Potential Changes and Impact on Contingency

Review with LCP Gatekeeper, 18-Jul-2011

Boundless Energy

Muskrat Falls Layout

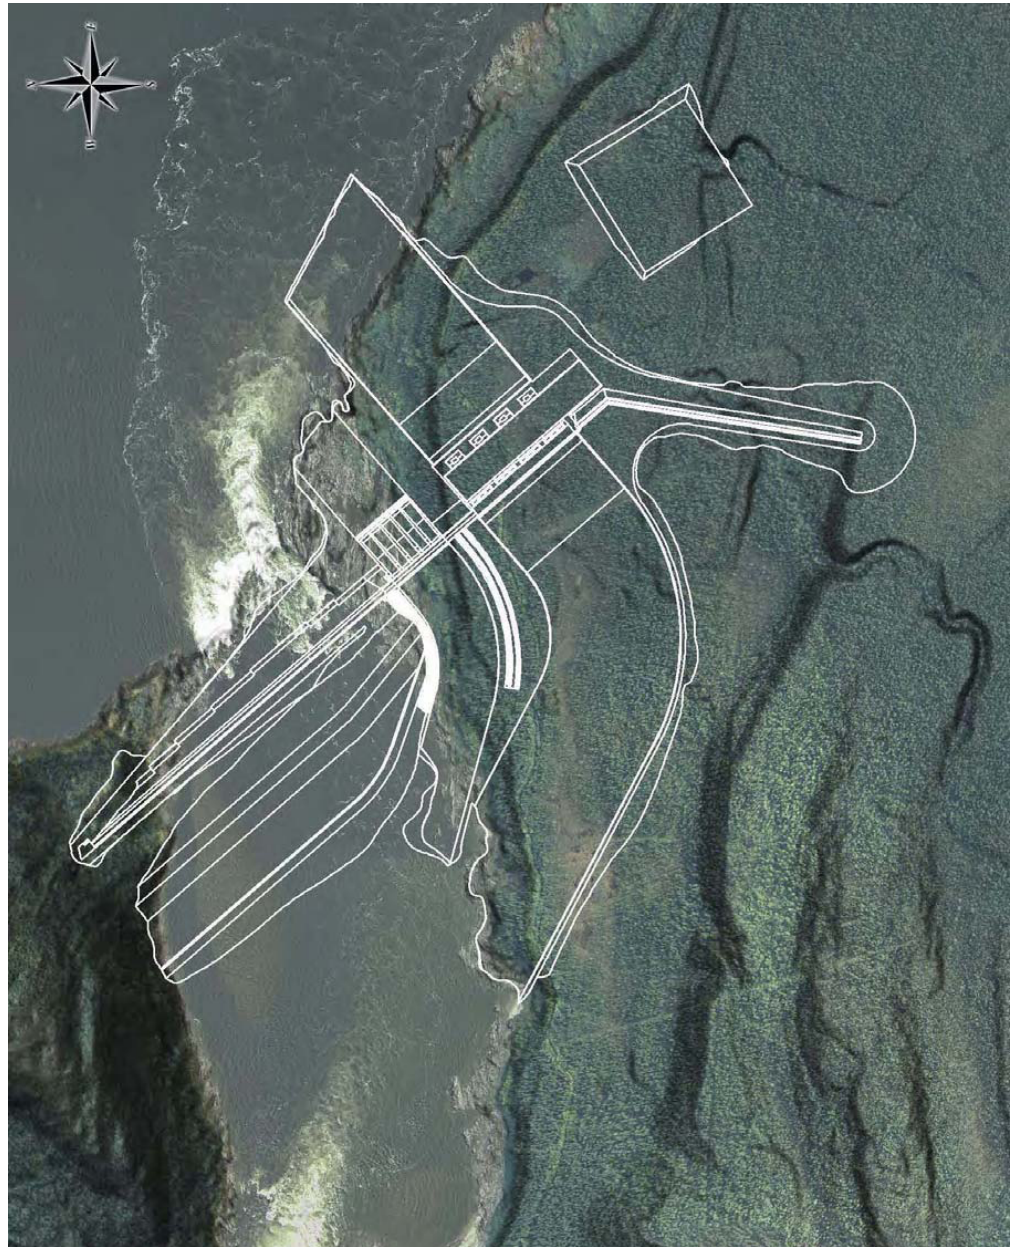
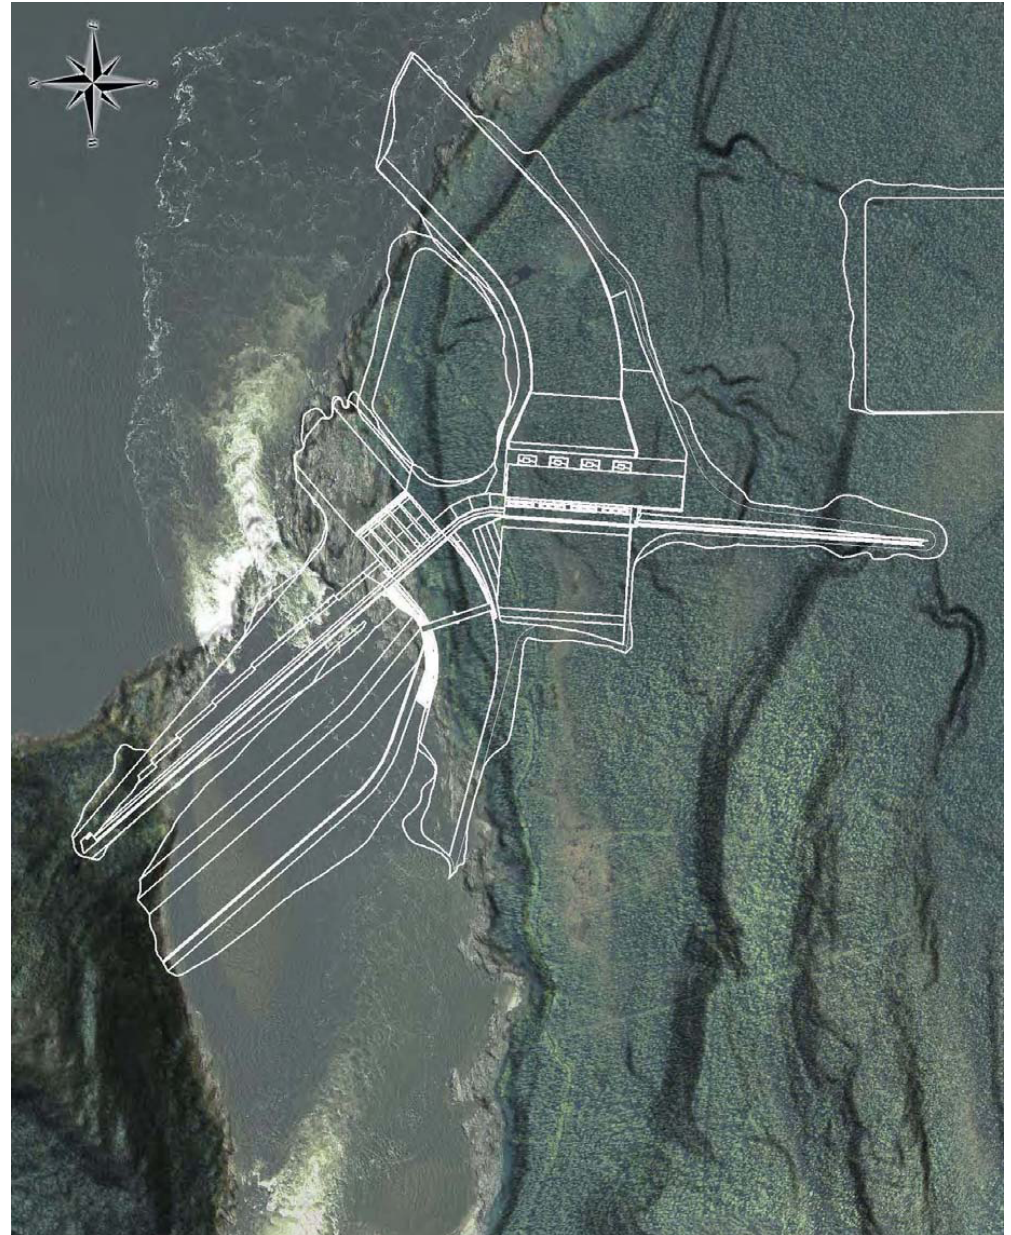
- DG2 estimate prepared based on plant layout and quantities in-hand at end of 2009
 - Key estimate uncertainty for DG2 related to “quality” of key quantities – original 1998 calculations could not be located
- MF1340 “Review and Confirmation of MF Layout, Structures and Interfaces” recently concluded
- Result is feasibility-level plant layout now with attendant “Bill of Quantities”
 - 3D modeling employed providing certainty wrt major quantities

- Finalization of plant layout / design maturity considering:
 - data from 2010 field program
 - hydraulic modeling results
 - impacts of constructing MF before GI
 - refined spillway configuration and operation
- Total cost impact near \$150 million
 - To be optimized
- Results in 3 distinct Project Changes
 - DAN-0018, 19 & 20

Muskrat Falls Layout – With 45° Rotation

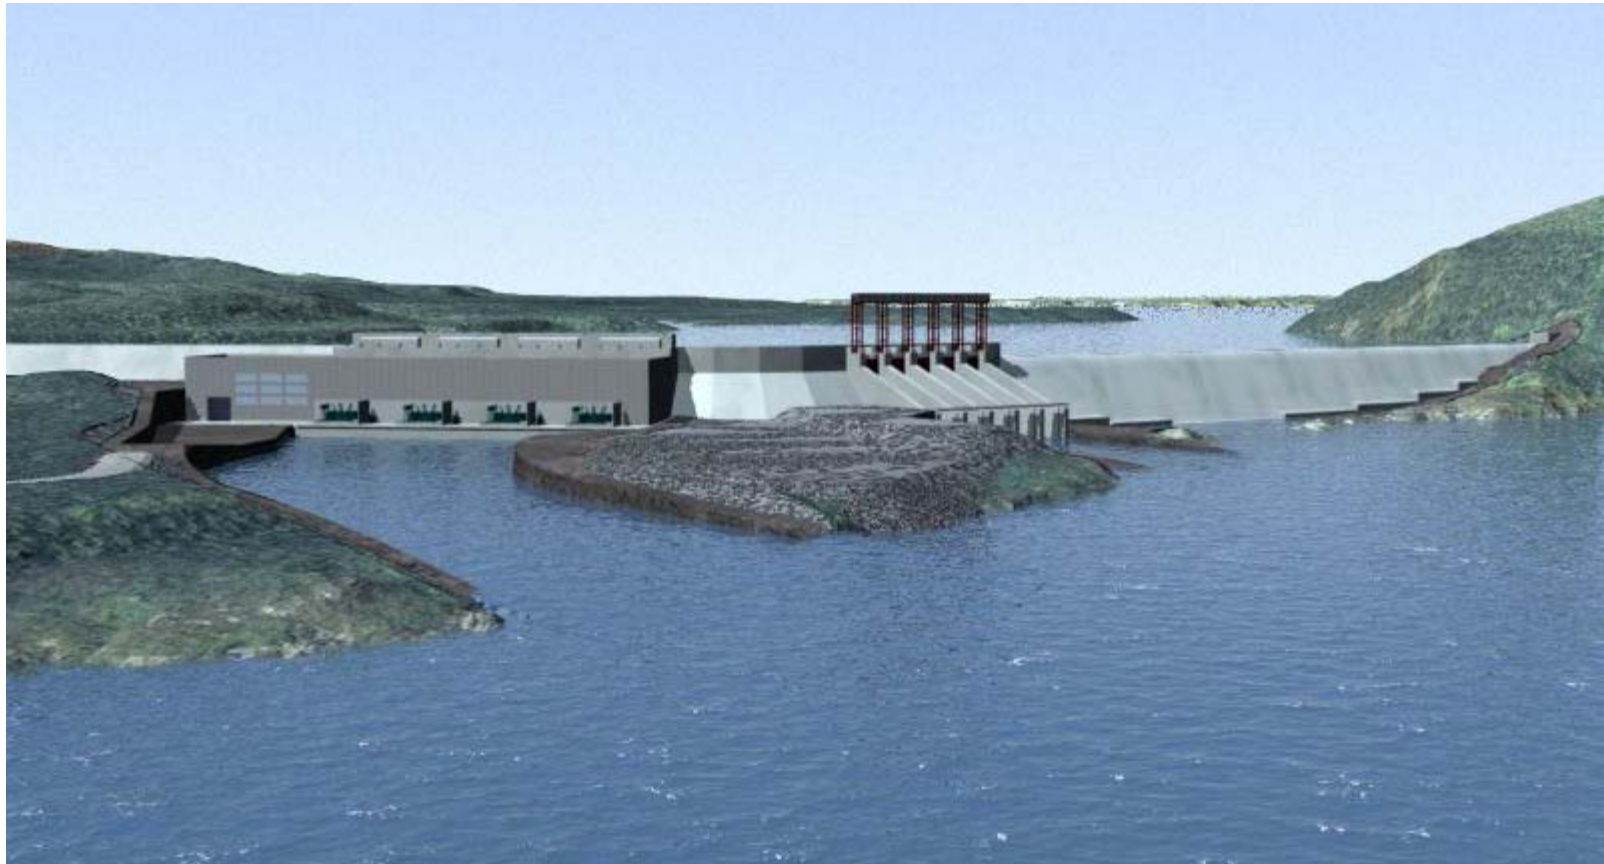
- **Potential Change:**
 - Re-orientation of MF Powerhouse / Intake by 45° to improve hydraulic conditions at Unit 1 Intake
 - Results in change in key quantities
- **Why this is a Change:**
 - DG2 based upon Variant 11, Scheme 3b layout and quantities
- **Rationale:**
 - Hydraulic conditions with existing provide inoperability conditions for T/G Unit 1 and high risk of cavitation

- Powerhouse pushed further into south side bank increasing bulk excavation quantities. Also lengthened tailrace, shorten approach channel, requirement for intermediate transition dams.
- Cost: \$50 to \$60 million
- Schedule: No impact to construction schedule

- Have agreed for SLI to move forward with the proposed layout in an effort to progress design
- PCN will be prepared to address Change

DAN-0003: LIL Overland TL Cost

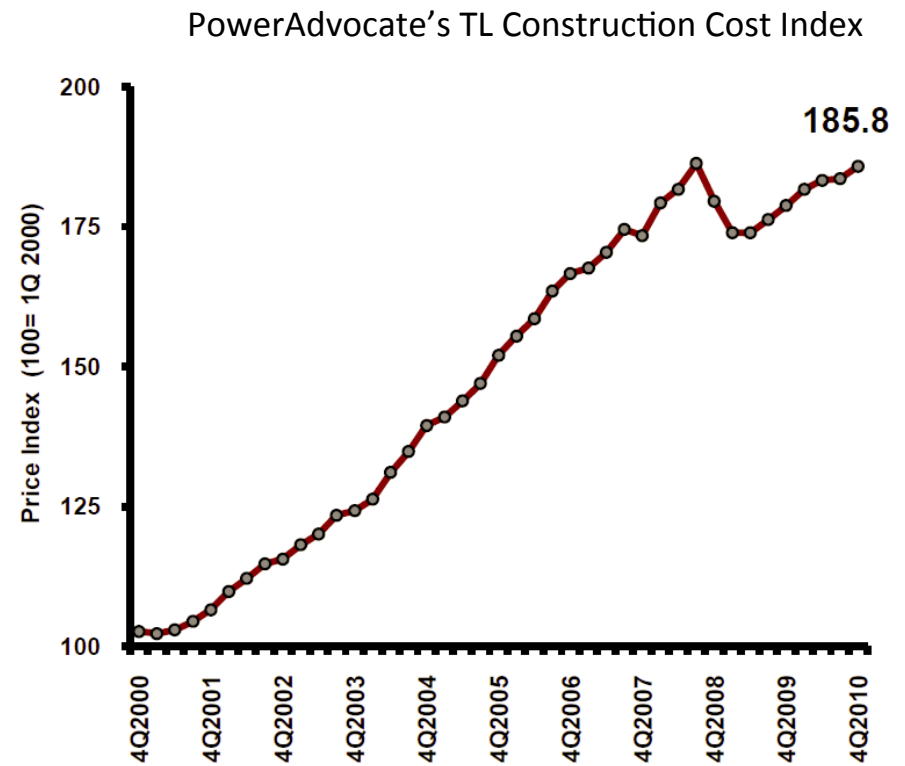
- **Potential Change:**
 - Increase in the construction cost for the LIL overland TL
 - Final corridor selection has increased line length by 30km
- **Why this is a Change:**
 - Significant change in estimated cost from DG 2 basis
- **Rationale:**
 - In the absent of having any preliminary design for the overland portion of the 320 kV TL, agreement to benchmark against NLH 230 KV TL construction norms, thus \$385k per km
 - Preliminary engineering and bottom-up feasibility-level cost estimate effort have indicated that \$490 to \$500k per km

- **Impact:**
 - Cost: \$120 to \$140 million
 - Schedule: No impact to construction schedule
- **Way-forward:**
 - SLI now proceeding with 350 kV system design and construction planning
 - DG 3 will include Class 3 estimate
 - Monitoring trends in material cost
